FINAL PRODUCT CHANGE NOTIFICATION**PCN:** PCN030043**DATE:** August 19, 2003

Subject: Addition of Nickel-Palladium-Gold (Ni-Pd-Au) Lead Finish to SOIC, TSSOP and SSOP Packages Manufactured at Cypress Manufacturing Limited Philippines Autoline

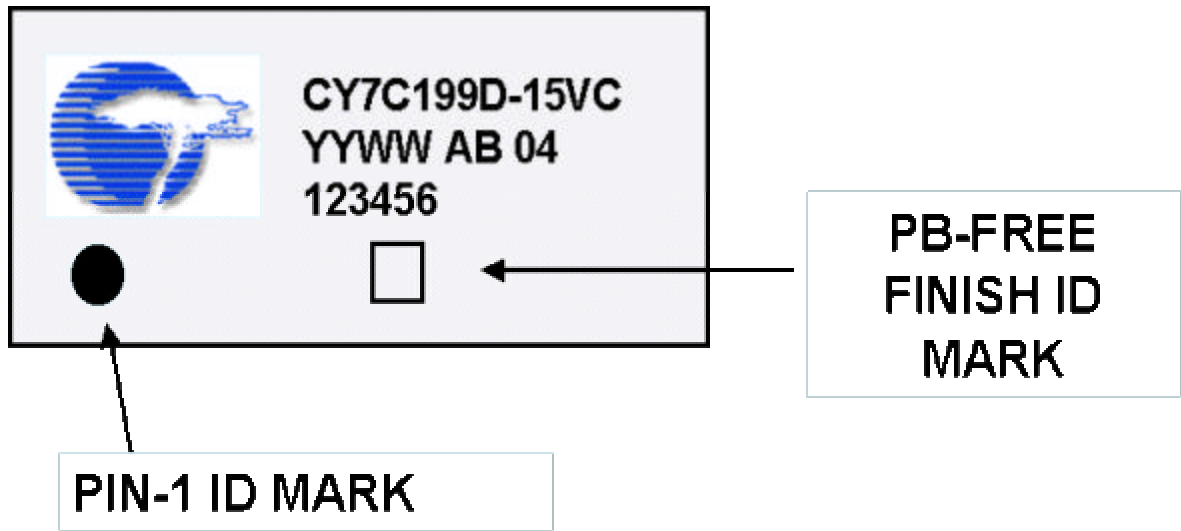
Part numbers will not change. The only difference is that the new lead finish will have a square marked next to the datecode (See attached illustration).

A square marked next to the datecode
